Re: *WMG Acquisitions LLC*
Amended Site Plan Application – BaySpace Armonk
100 Business Park Drive (108.03-1-51)

RE: JMC Project 22090
BaySpace Armonk
100 Business Park Drive
Town of North Castle, NY

Response to Town Comments Resubmission

Drawn	NC	Approved	DL
Scale	1" = 30'		
Date	09/12/2022		
Project No.	22090		
Zone	SE	LAY	L_LAY
Drawing No.	C-100

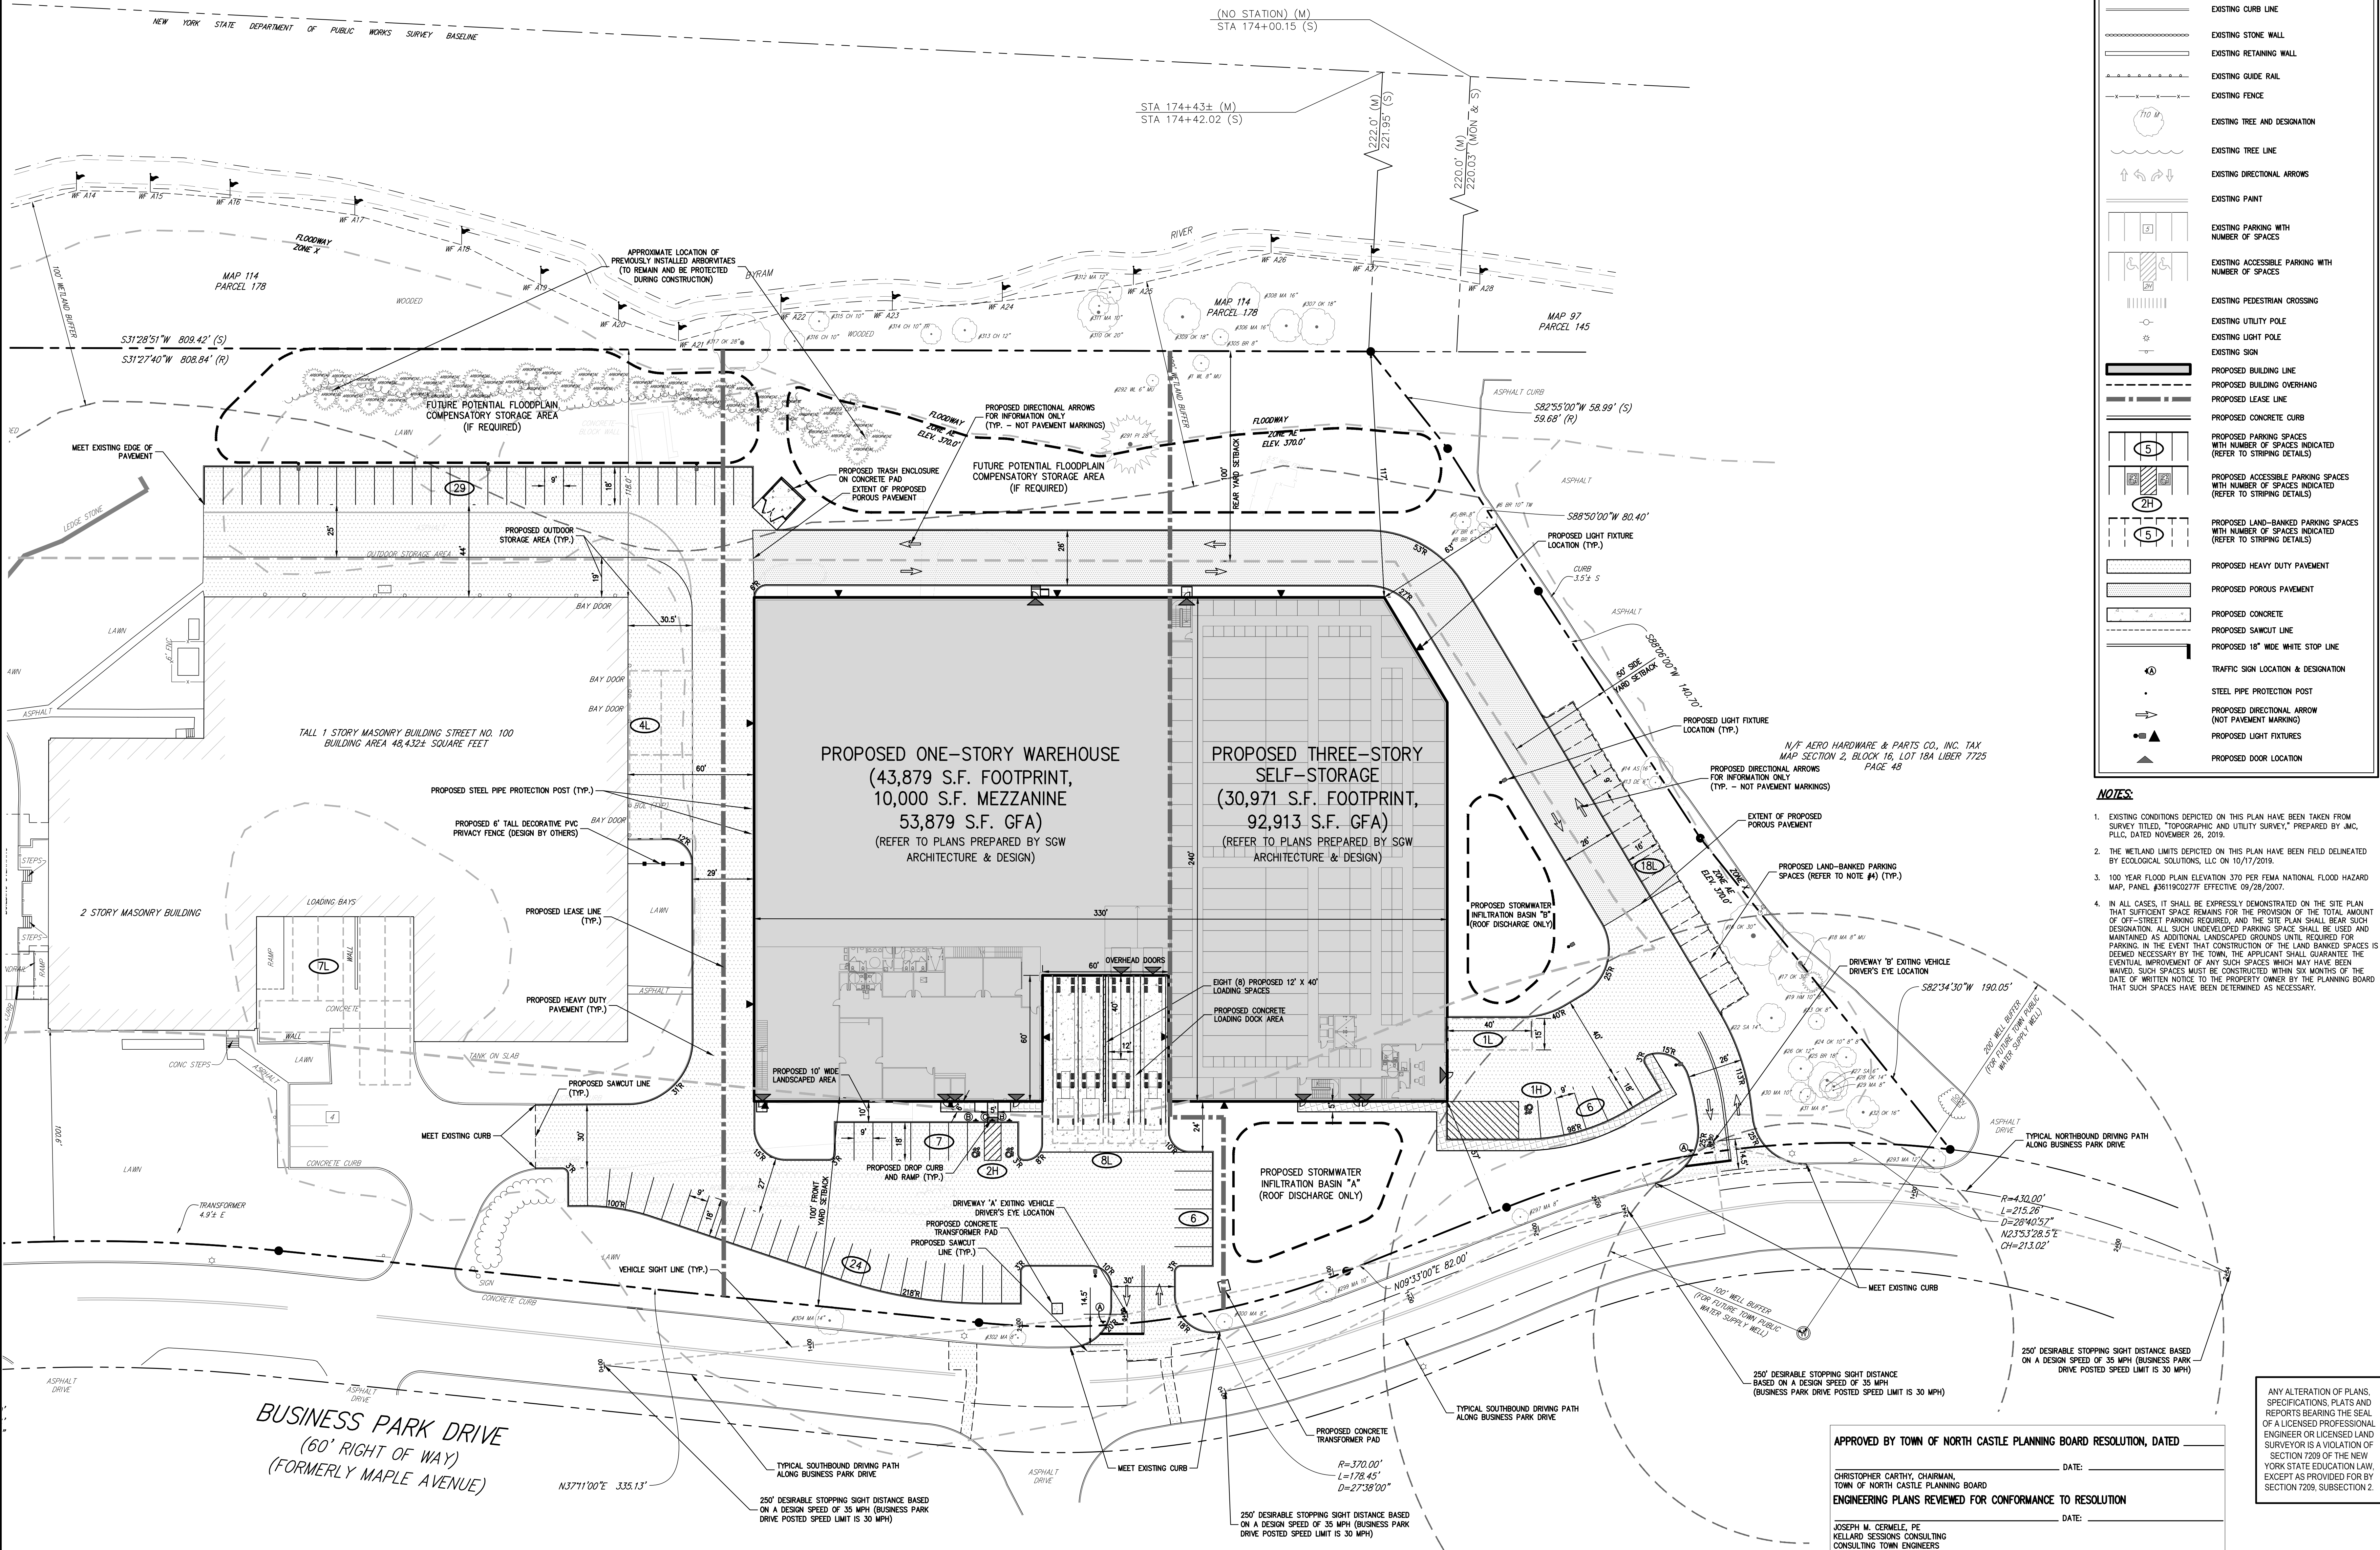
The site is required to provide 277 off-street parking spaces, but only 220 are provided. The Applicant should provide a plan depicting the location of all 220 off-street parking spaces for review.

The comment is so noted. Application to the Town of North Castle Zoning Board of Appeals for an area variance for proposed off-street parking will be made upon referral from the Planning Board. The 220 proposed off-street parking spaces have been depicted on JMC drawing C-100 "Overall Site Layout Plan" last revised 10/24/2022.

SITE LANDSCAPING & WETLAND MITIGATION PLAN

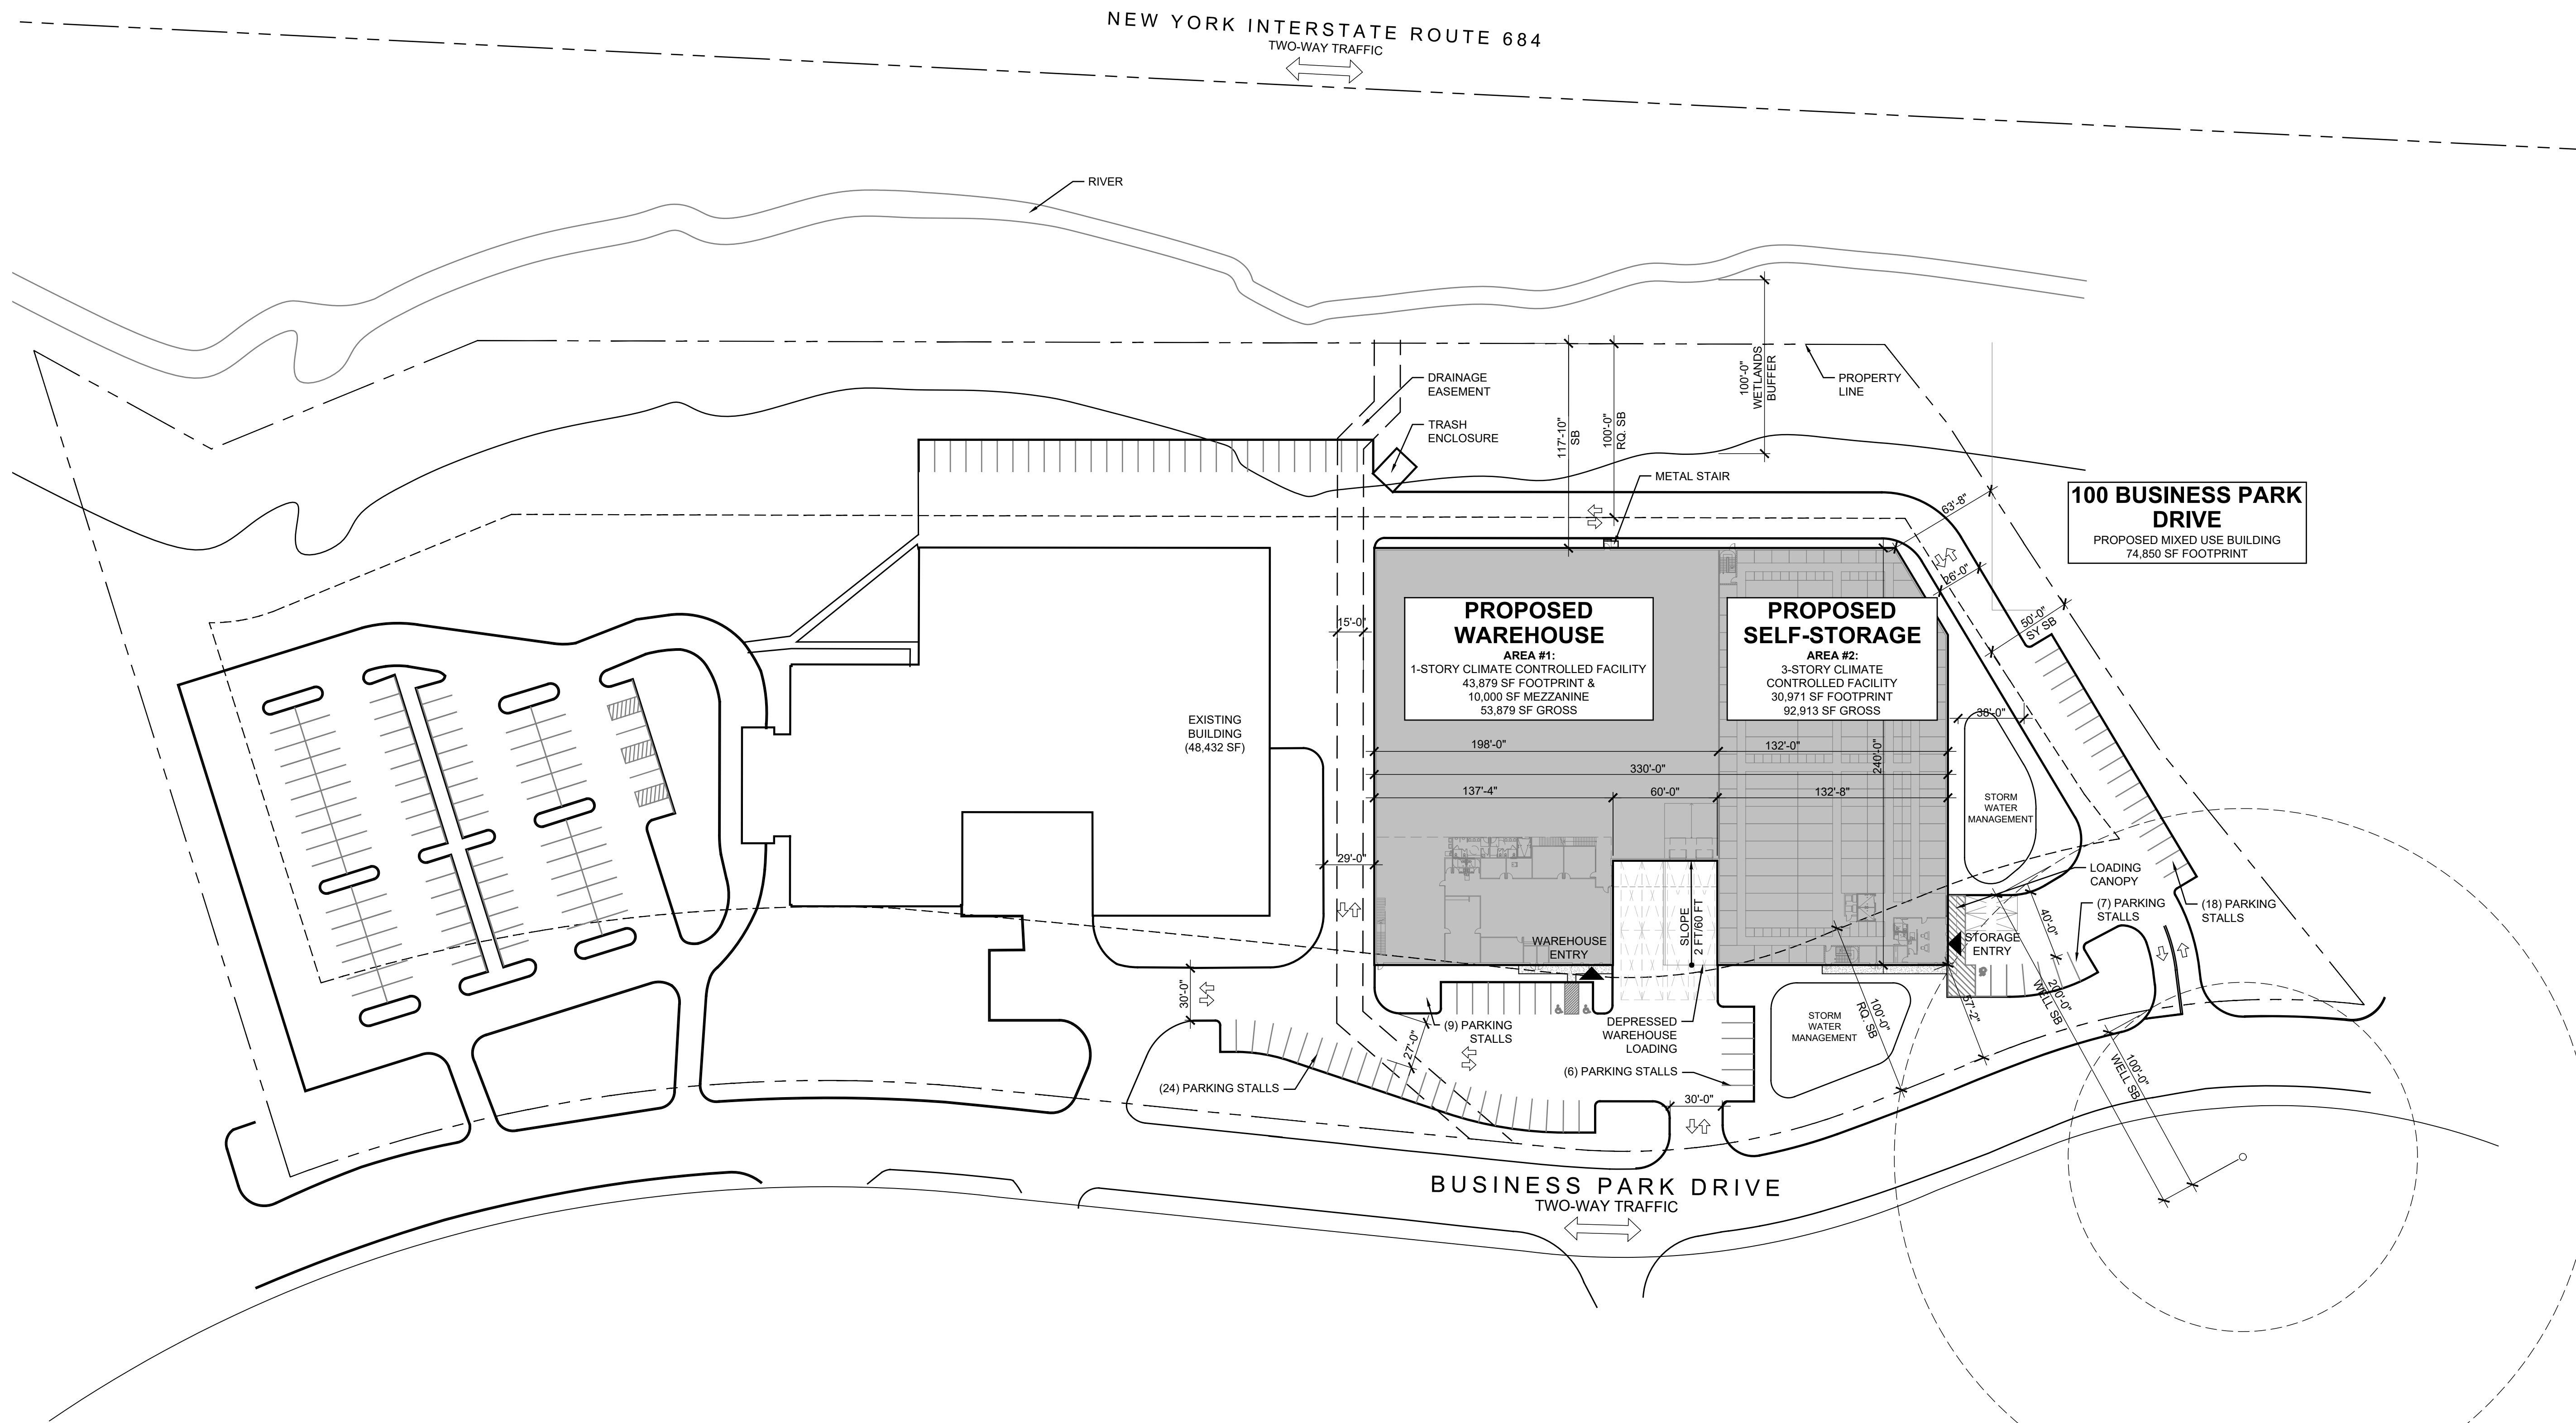
The site plan depicts outdoor storage at the rear and side of the existing building. Given that the new building will accommodate the public for the self-storage use and given the difficulty the Applicant has had in containing outdoor storage to previously approved locations, it is recommended that all outdoor storage be prohibited on the site and all material shall be required to be placed in the existing and/or proposed warehouse.

As discussed during the 09/29/2022 Planning Board meeting, we have added additional screening for the previously approved outdoor storage area along the southeast and east sides of the existing office/warehouse building. The southeast side of the outdoor storage area is proposed to be screened (from Business Park Drive) by a 6' high decorative privacy fence, supplemented by evergreen plantings and the east side of the outdoor storage area is proposed to be screened (from Interstate 684) by existing evergreen tree plantings recently installed by the previous applicant (A&R Real Estate Holdings LLC). Refer to JMC drawing C-101 "Site Layout Plan", last revised 10/24/2022 and JMC drawing C-500 "Site Landscaping & Wetland Mitigation Plan", last revised 10/24/2022.
